LINCOLN PARK PLANNING COMMISSION
CITY HALL – COUNCIL CHAMBERS 1355 SOUTHFIELD ROAD
LINCOLN PARK, MICHIGAN

**Re: Auto Repair Facility Site Plan
970 Fort Street
City of Lincoln Park, MI
Hennessey Project 72111**

Regarding: Applicant for Site Plan Review and Special Land Use – 970 Fort St (Auto Sales and Service)

SHEET #: SP-4

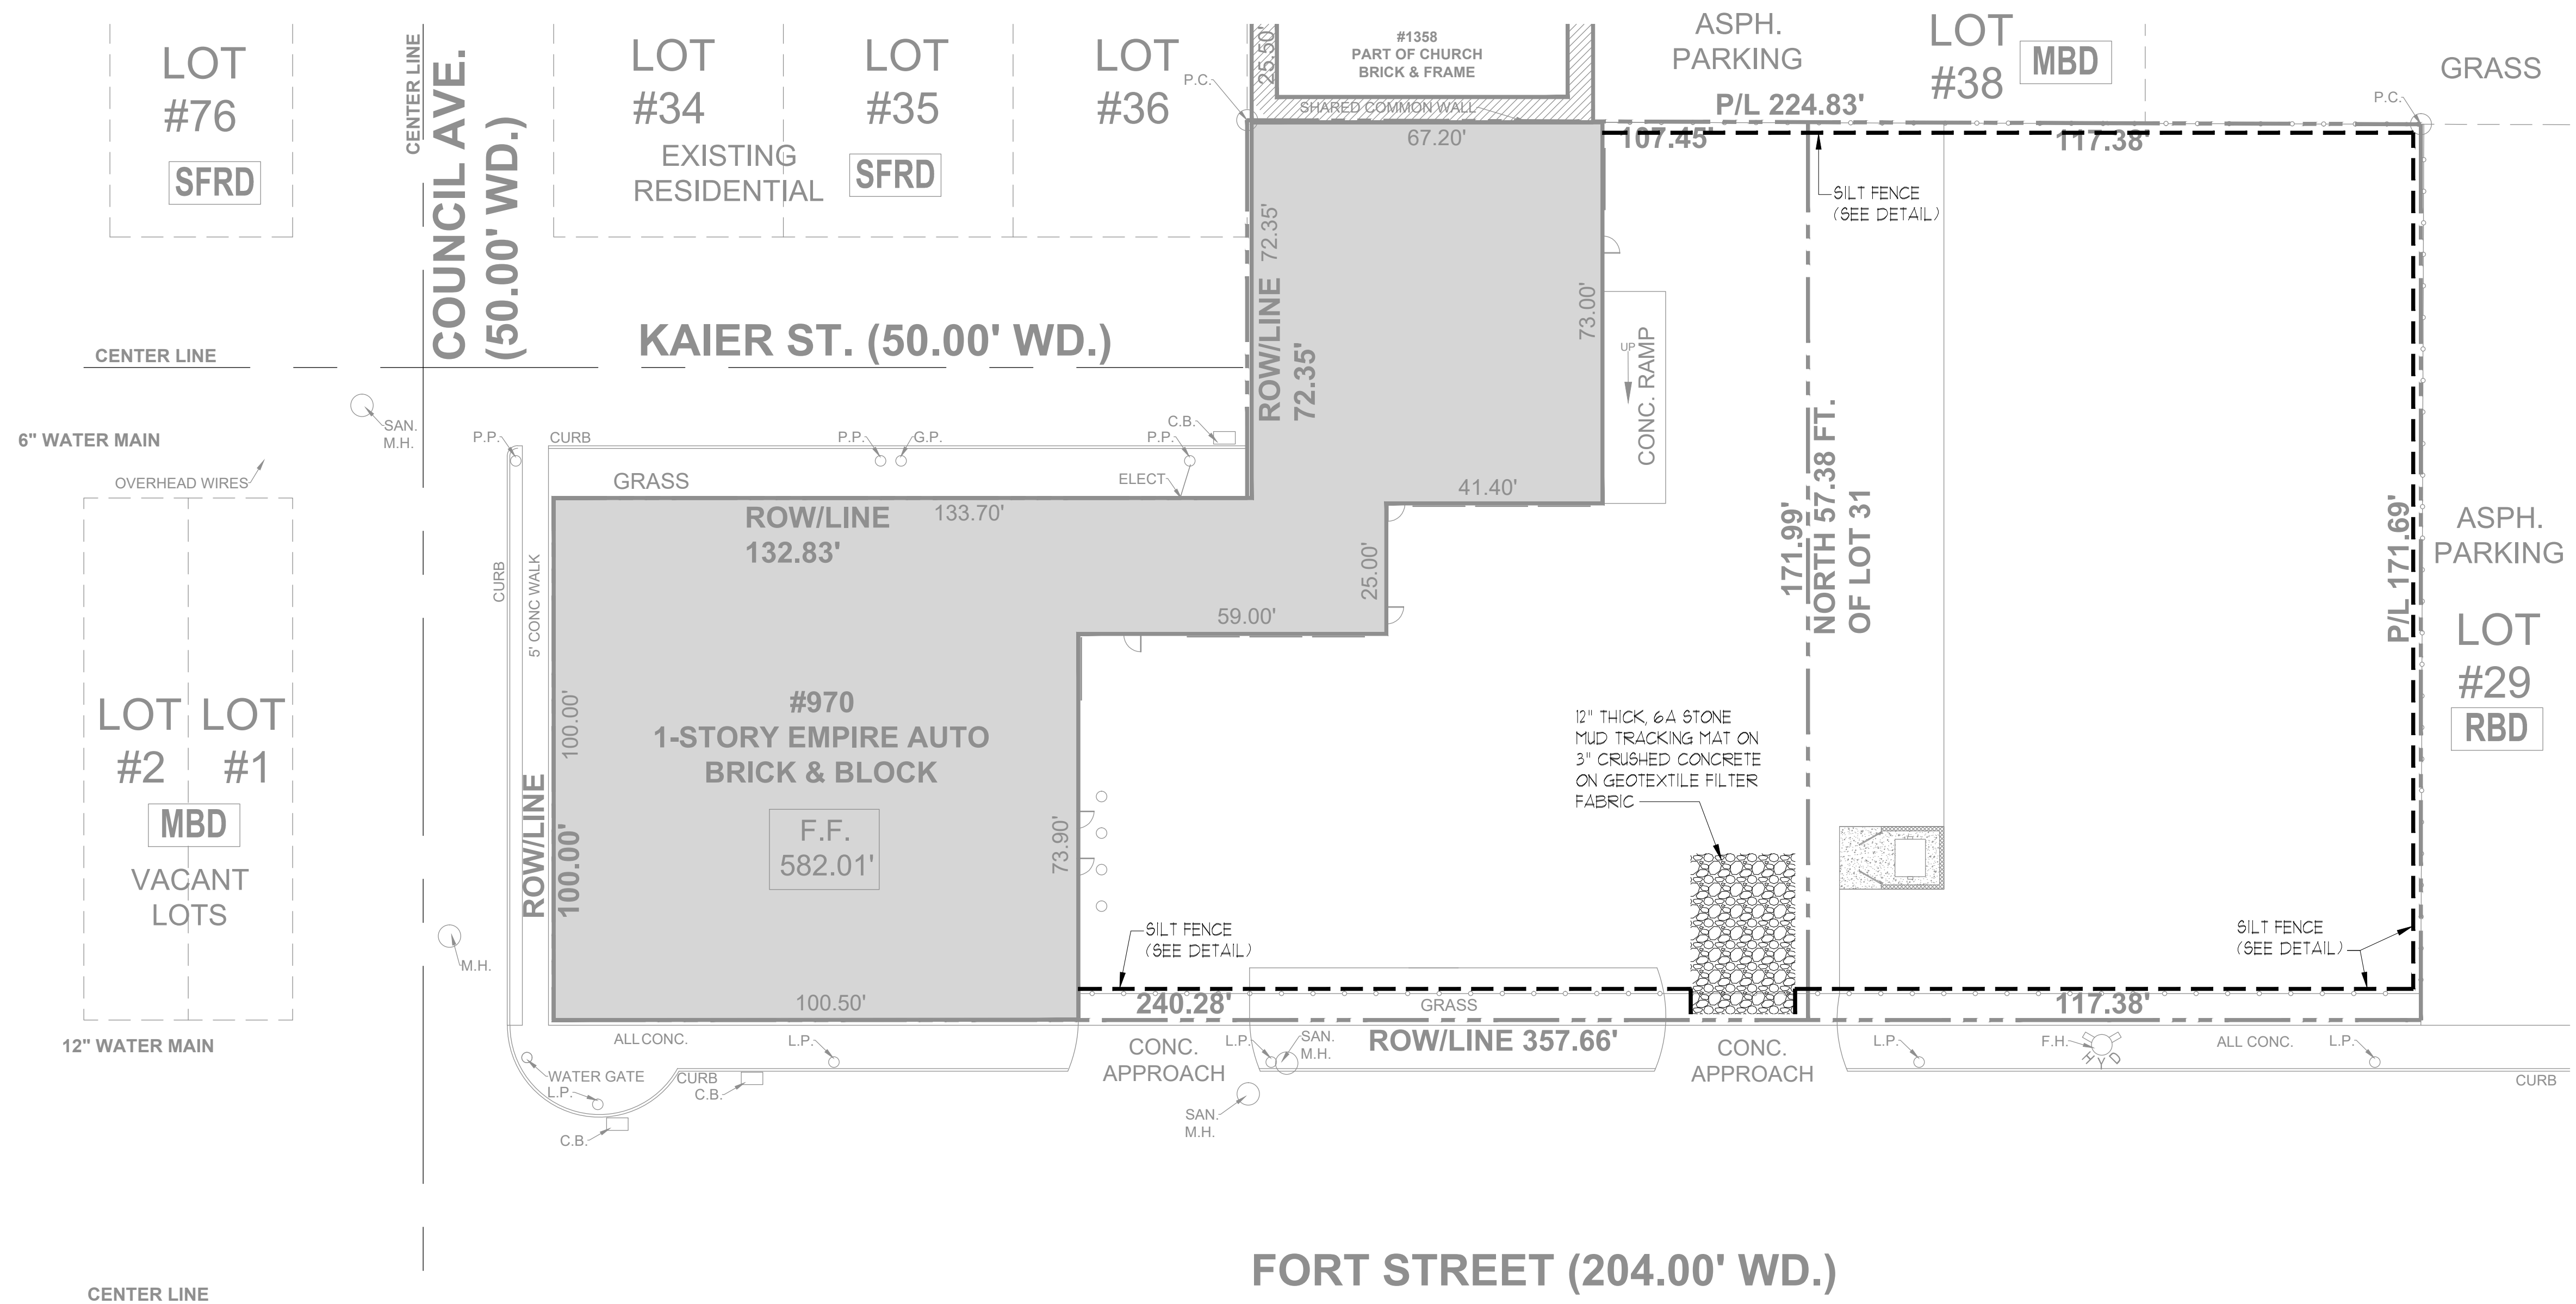
1. Based on the site plan submitted, all existing utilities and leads are being reused. It is our recommendation that the new addition should be serviced by new water and sanitary sewer services. If the existing services are approved for tie-in by the Plumbing Inspector it is important that the developer realize these existing utilities are very old and may have reached their life expectancy. It is our strong recommendation for the developer to at least videotape the existing sewer lead to determine its condition prior to doing any renovations on the existing building. If the service lead needs to be replaced the installation of the new service will need to be inspected by our office. The developer should verify with the City the existing sanitary service type and size. If it is undersized for the proposed building use it must be replaced. The developer's engineer or architect shall determine the sanitary service lead capacity.

2. The developer should verify with the City the existing water service type and size. If it is a lead service or if the service is undersized for the proposed building use, it should be replaced. The developer's engineer or architect shall determine the water service lead capacity.

- *Applicant is recommended to videotape the existing sewer lead to determine its condition prior to doing renovations on the existing building, if the service lead needs to be replaced the installation of the new service will need to be inspected.*
- *Applicant shall verify with the City the existing sanitary service type and size. If it is undersized for the proposed building use it must be replaced. The applicant's engineer or architect shall determine the sanitary service lead capacity.*

- *Applicant shall verify with the City the existing water service and size. If It Is lead service or If Is undersized for the proposed building use, it should be replaced. the applicant's engineer or architect shall determine the water service lead capacity.*
- *Applicant shall work with City Engineer of Lincoln Park Department of Public Services to review the public water and sewer systems on the site.*
